91-2, *Publication Date: JANUARY 23, 1991*

| <ul style="list-style-type: none">• Chassis - Low Clearance Concerns - Low Profile Or Low Rider Models With 6.6L And 7.8L Ford Diesel Engines• Oil - Filter - 6.6L And 7.8L Ford Diesel - New Shorter Filter Available for "Low Profile Or Low Rider" Models | Article No. 91-2-14 |

MEDIUM/HEAVY TRUCK:

1987-91 CARGO SERIES, F & B SERIES, L SERIES

Figure 1 - Article 91-3-13

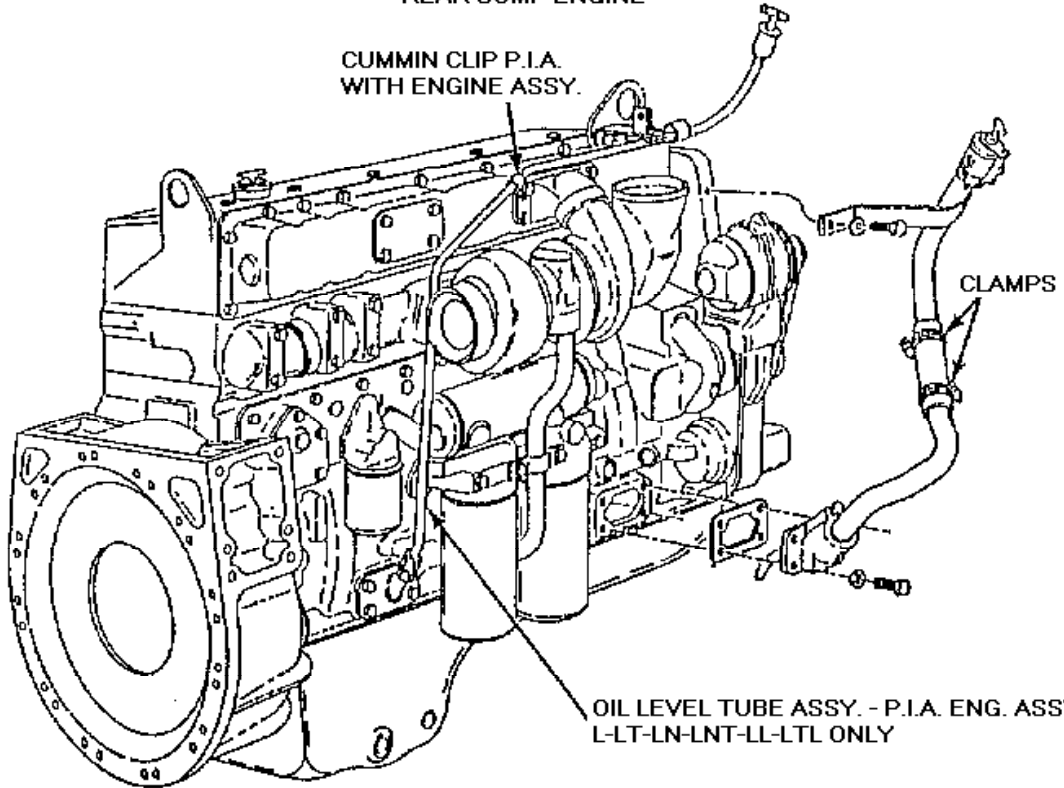
The one-piece oil filler tube assembly may crack where the tube is welded/brazed to the mounting plate. In addition, the dipstick guide tube may interfere with the oil pick-up tube on rear sump oil pan applications. An oil leak may result because this interference causes the mounting plate not to rest flat against the engine mounting surface.

1. Cut off and throw away the original plugged dipstick guide tube. (The "dummy" tube is not needed in this application.) Make the cut near the mounting plate, about an inch away.
2. Plug the shortened tube with the original plug (-6B507-) which can be removed from the tube that was just cut off.
3. Modify the existing one-piece oil filler tube as follows:
 - a. Cut the tube about 10" from the mounting plate between the two bends, Figure 1.

- b. Install a rubber hose between the tubes, Figure 1.
- c. Secure the hose with two (2) hose clamps (D9AZ-8287-E).

Figure 1 - Article 91-5-13

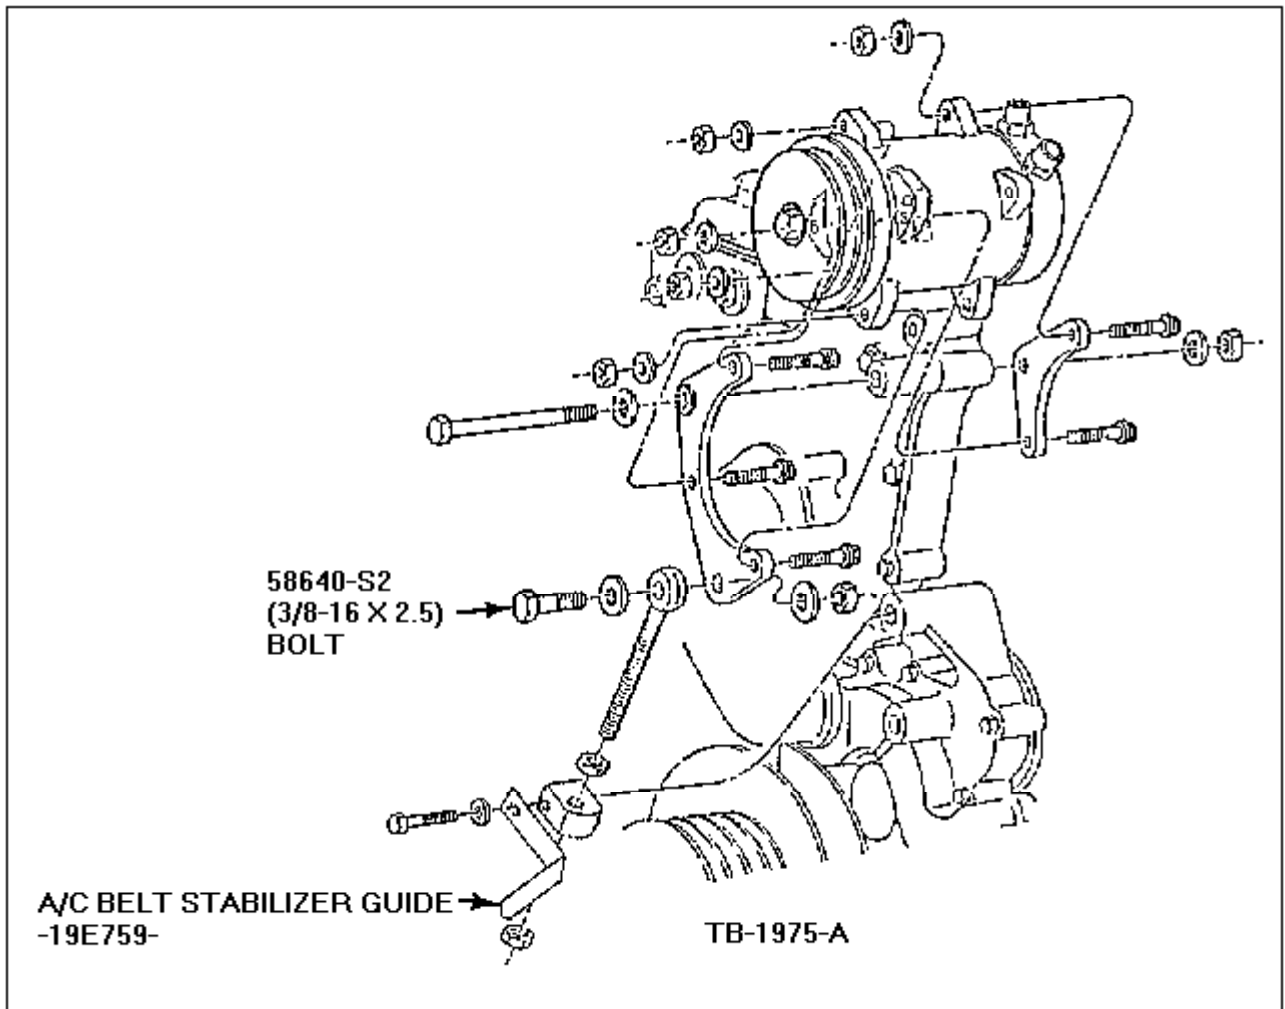
1. Use a 1/2" drive belt for both the 6.6L and 7.8L engine applications.
 - 6.6L - Use belt C9PZ-8620-CZ
 - 7.8L - Use belt E4PZ-8620-B
2. Install a drive belt stabilizer guide (F1HZ-19E759-A) on the tension side of the the belt circuit, Figure 1.

Figure 2 - Article 91-5-13

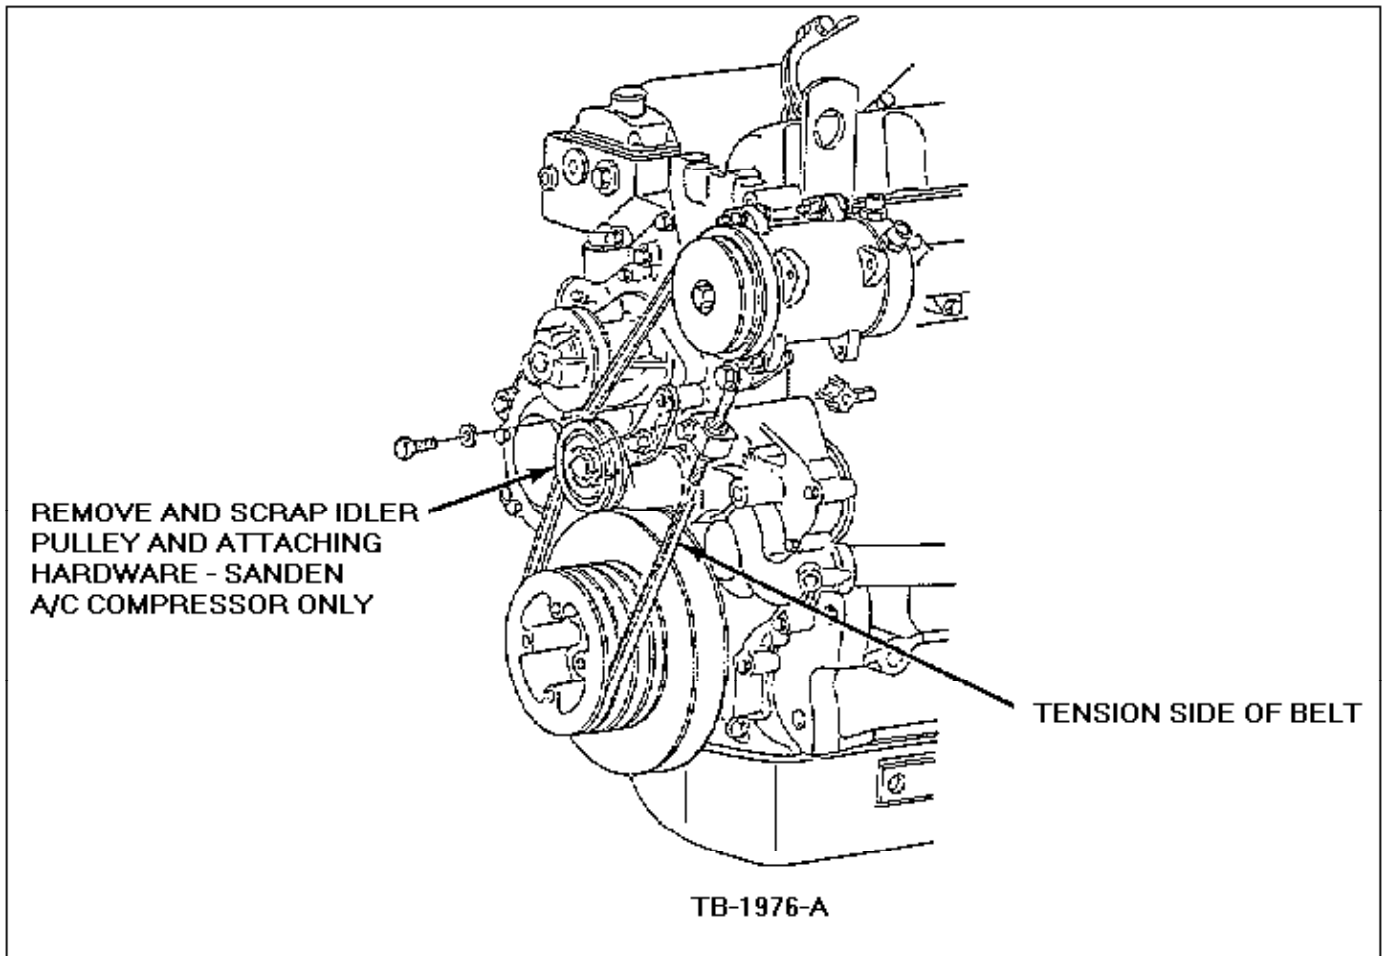
3. Remove and scrap the idler pulley and attaching hardware from the slack side of the belt circuit, Figure 2.

Figure 1 - Article 91-6-8

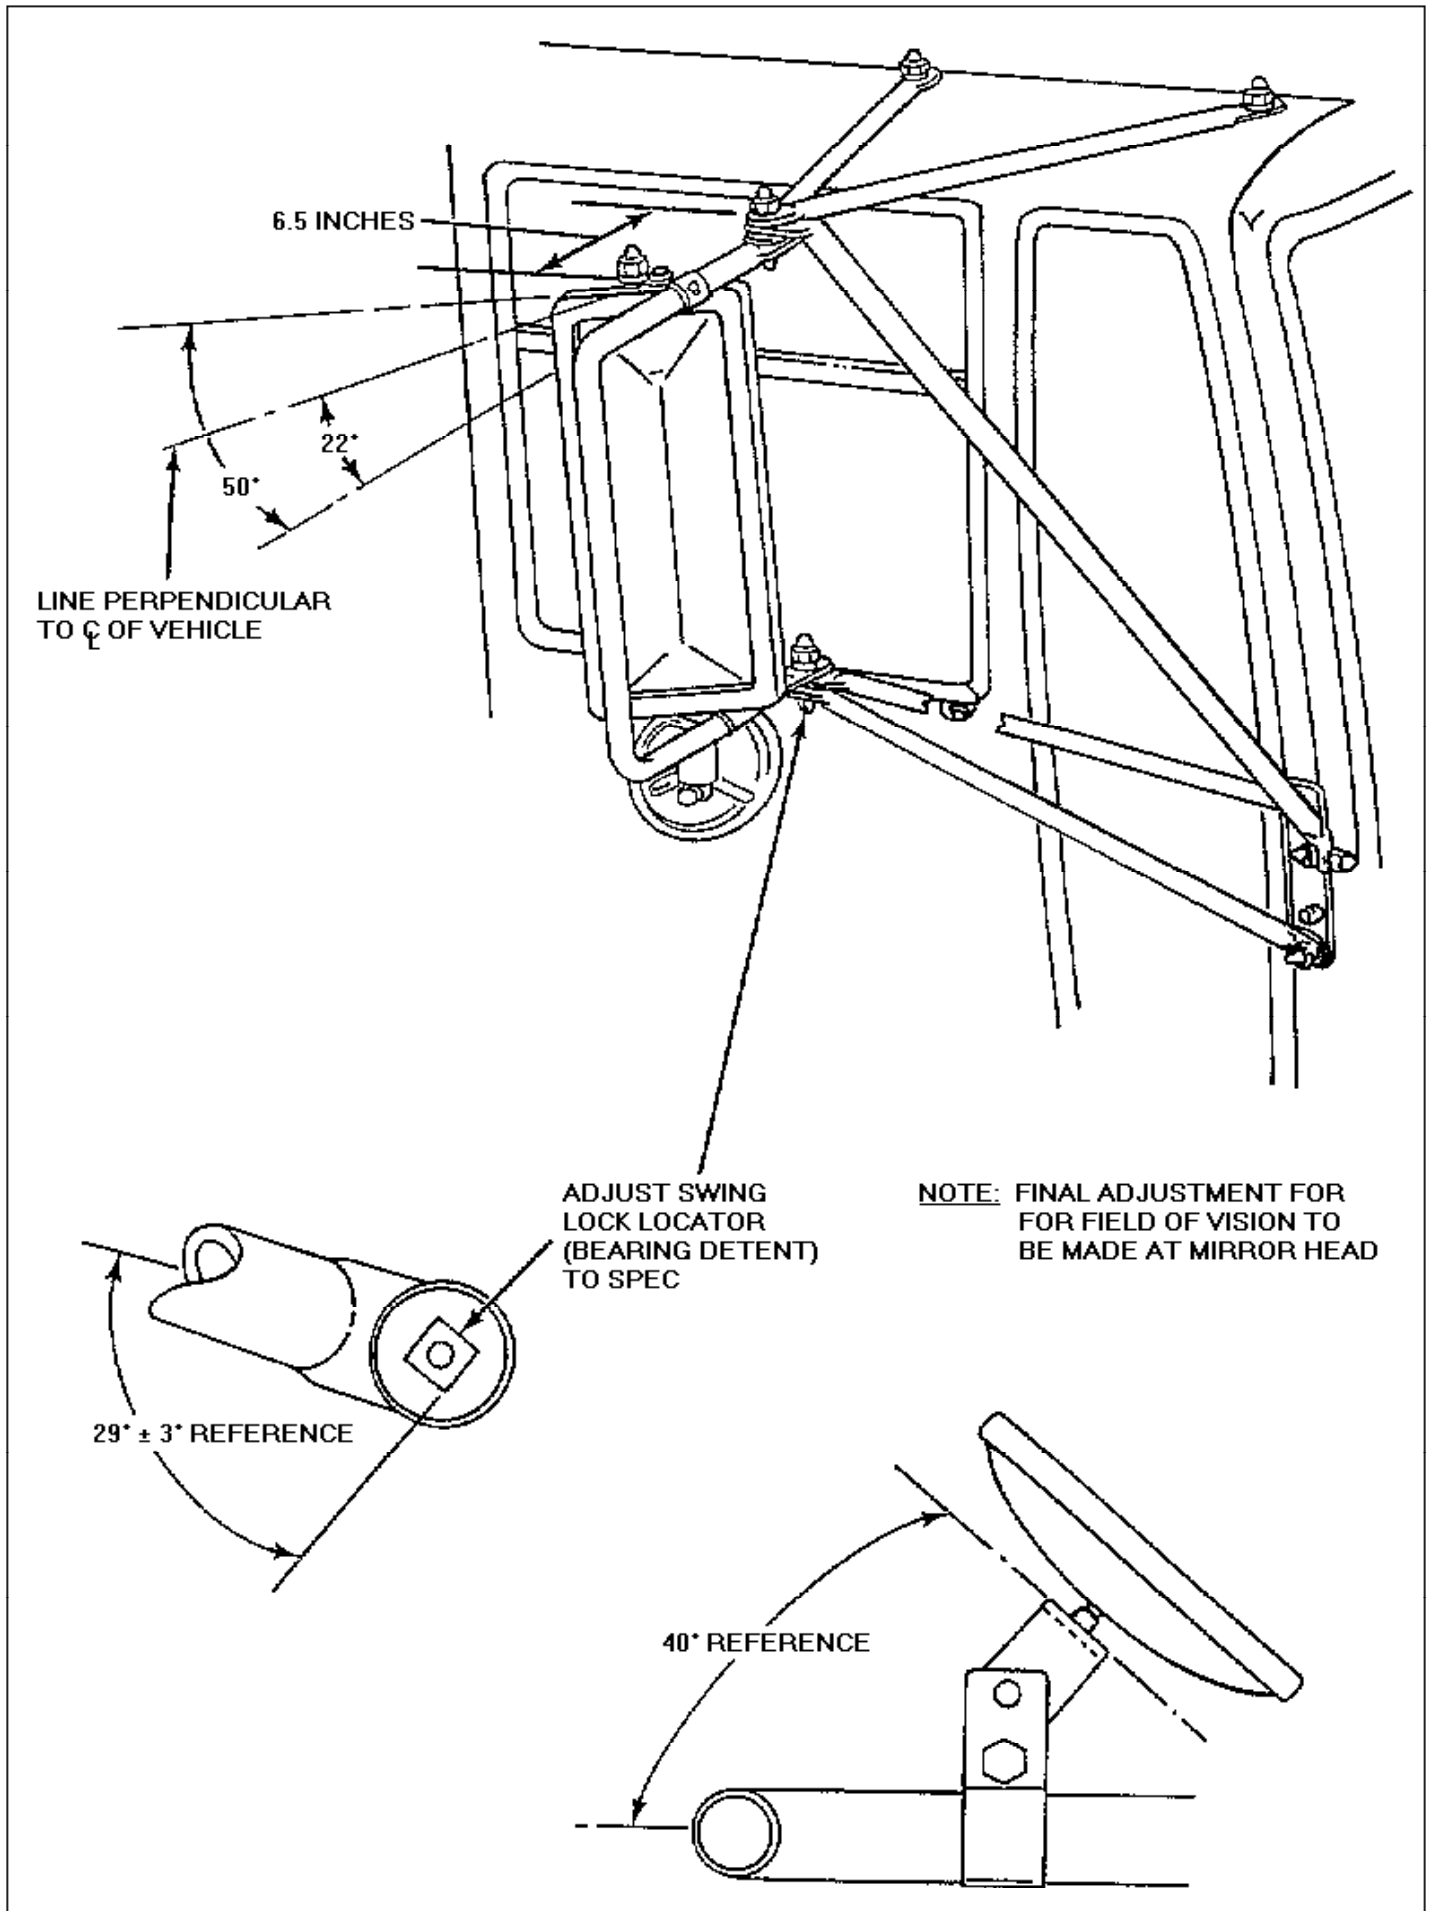
Adjust the RH rear view mirror to provide adequate visibility, Figure 1. Refer to the 1991 Cargo Truck Shop Manual, Section 35-50, for correct installation torque specifications.

THE CORRECT ADJUSTMENT OF THE RH MIRROR IS NOT SYMMETRICAL WITH THE LH MIRROR. THEREFORE, WHEN THE RH MIRROR IS PROPERLY ADJUSTED, IT WILL BE APPARENT THAT THE RH AND LH MIRRORS ARE NOT IN THE SAME POSITION.

Figure 1 - Article 91-6-9

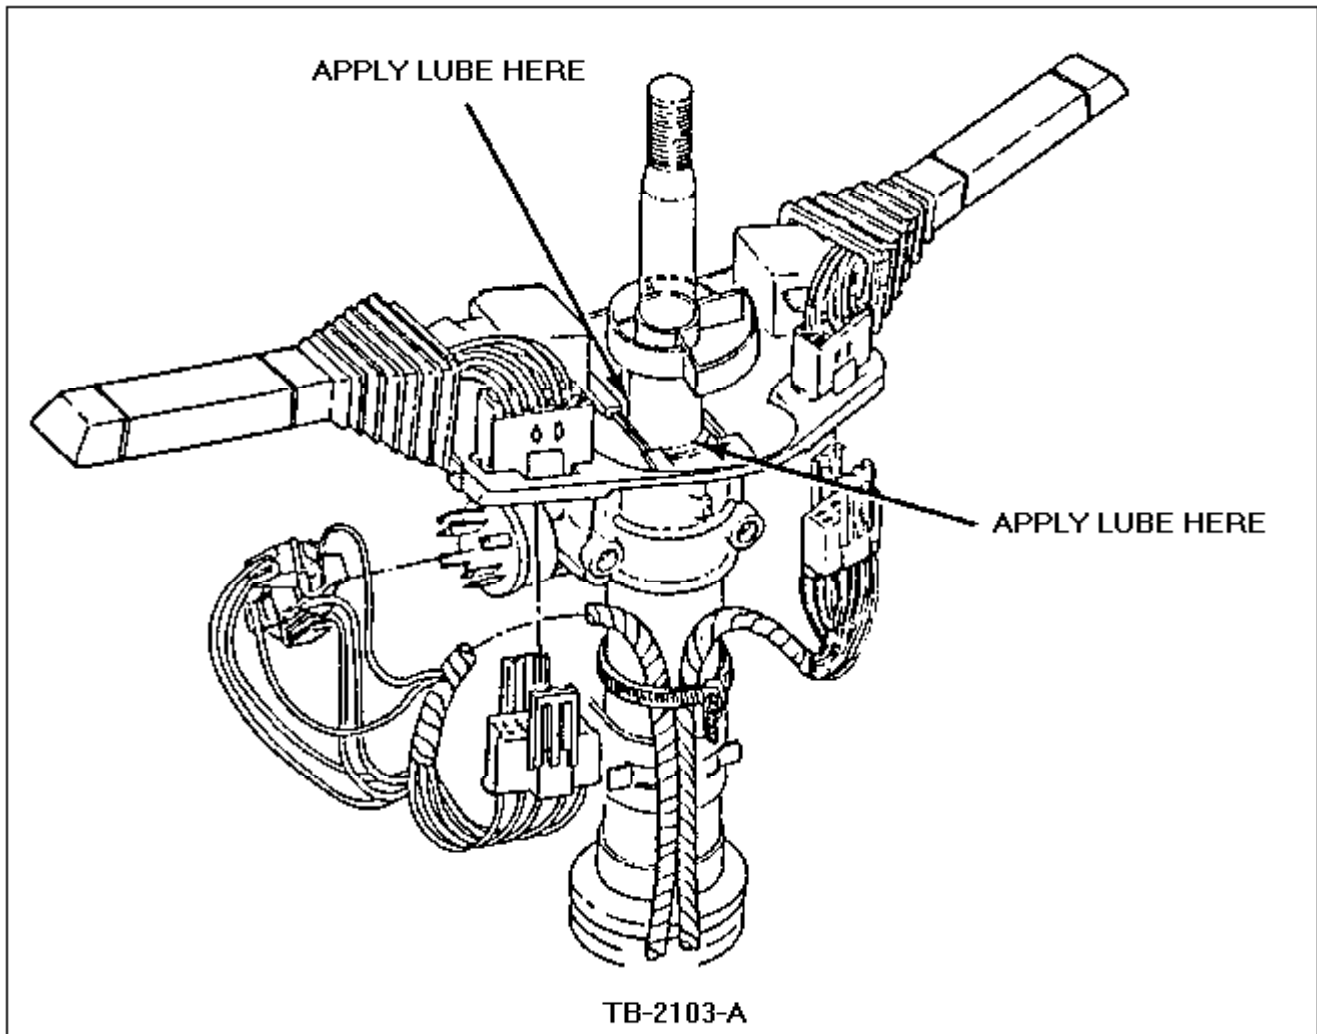
1. Remove the steering column shroud from the left hand side of the column.
2. Apply Ford Multi-Purpose Grease on the bottom flange of the turn signal return cam. Refer to Figure 1.

3. Turn the steering wheel to distribute the lube and verify the squeak is eliminated.
4. Re-install the steering column shroud.

Figure 1 - Article 91-7-16

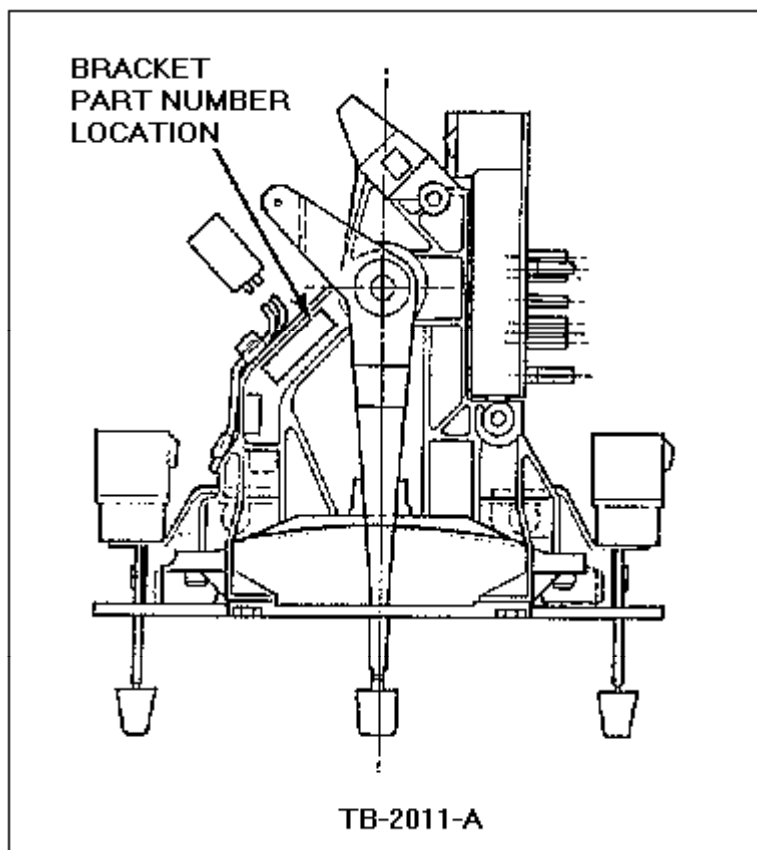
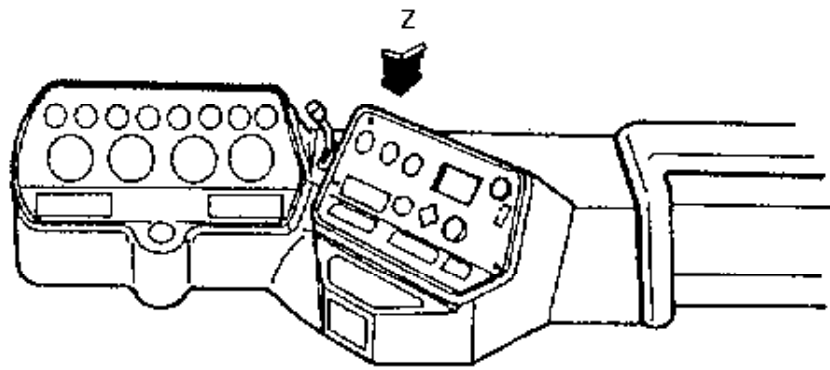
1. If the climate control assembly is obtained from dealer stock, make sure it is the latest design level.
 - a. Look for the bracket part number (E4TH-18352-AA), Figure 1. This specific part number indicates that it is of the latest design level.

Figure 2 - Article 91-7-16

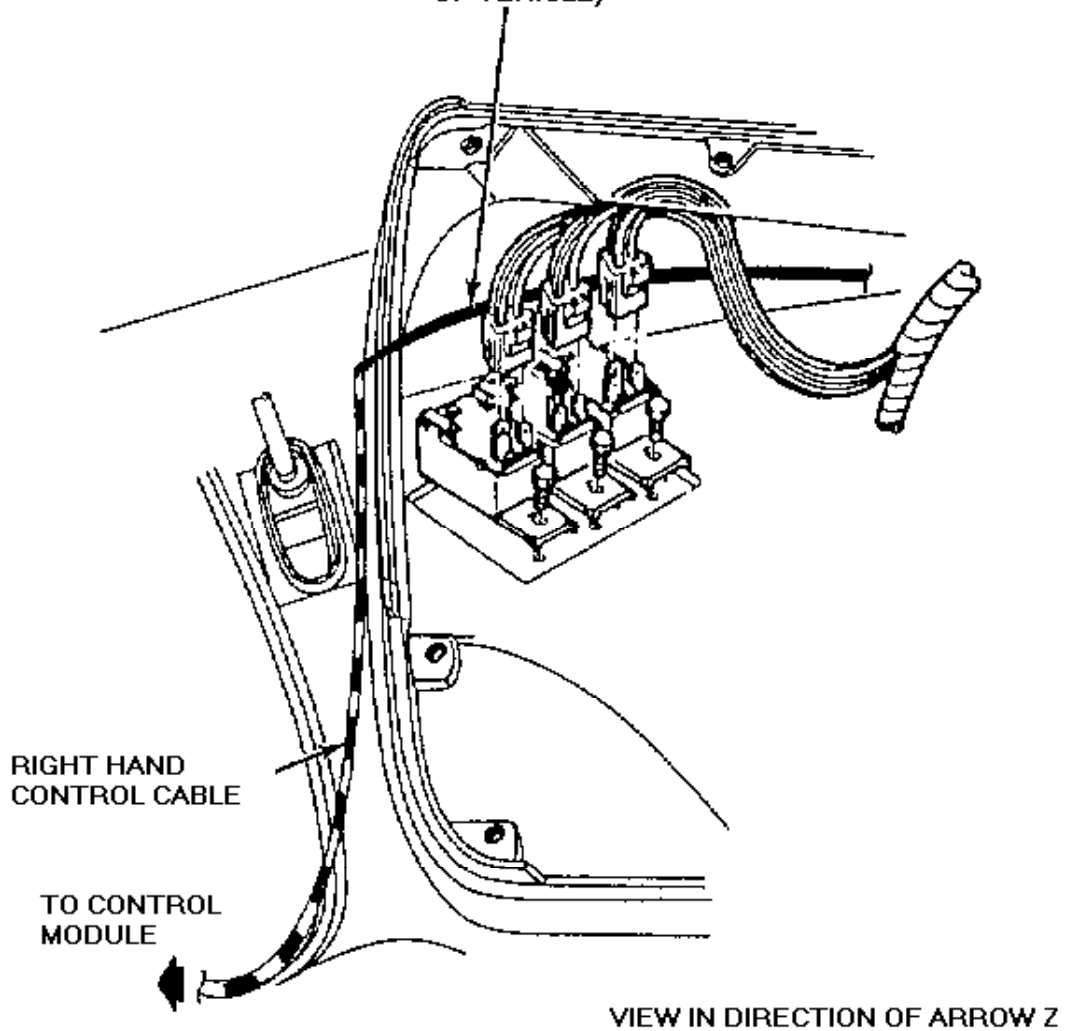
- b. The part number is moulded into the part and is visible without disassembly of the module.
2. Install the climate control assembly. Refer to the 1987-91 CL/CLT-9000 Series Truck Shop Manual, Section 36-21-63, for installation details.
3. Check to see if the truck has the RH temperature control cable incorrectly routed in front of the light relays. This reduces the cable bend radius which may result in increased operating efforts.
4. If the cable routing is in front of the light relays, reroute it as follows.
 - a. Reroute the RH control cable so that it passes behind the light relays toward the front of the vehicle, Figure 2.

Figure 3 - Article 91-7-16

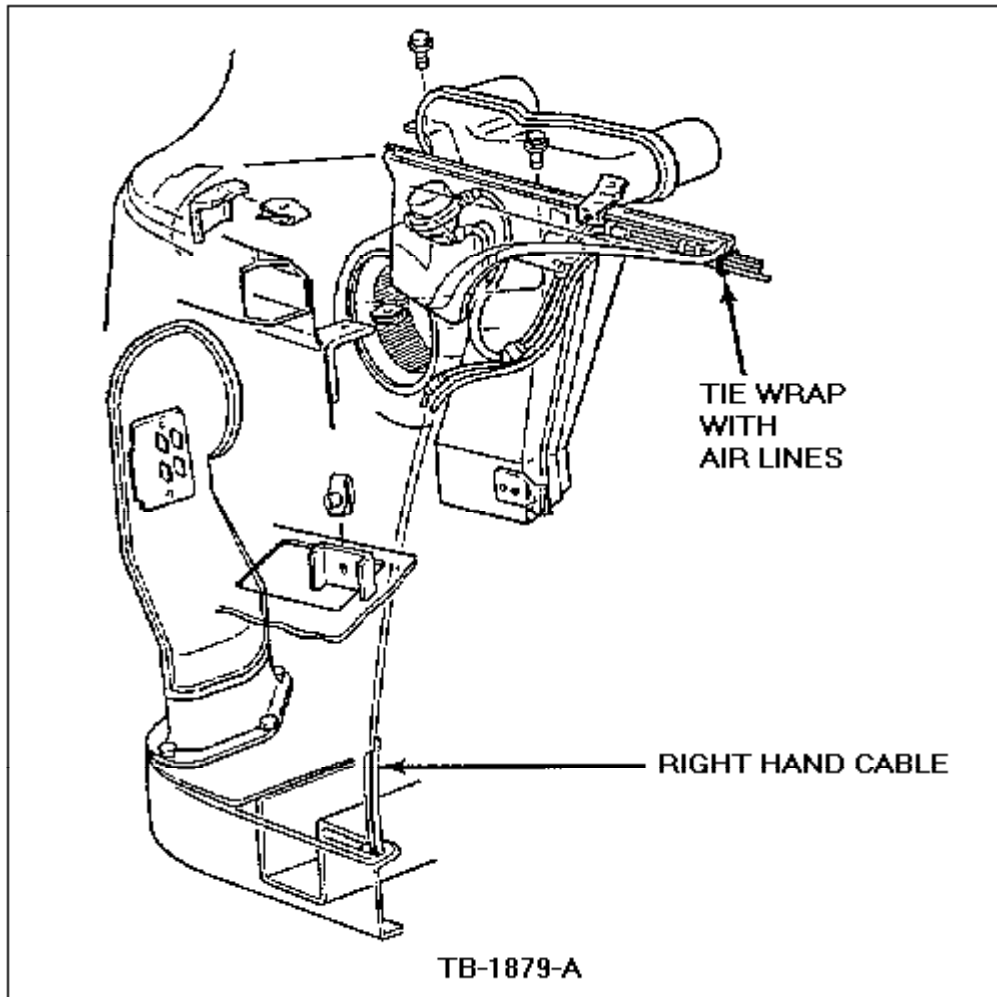
- b. Tie wrap the cable with the air lines to assure it doesn't shift position, Figure 3.
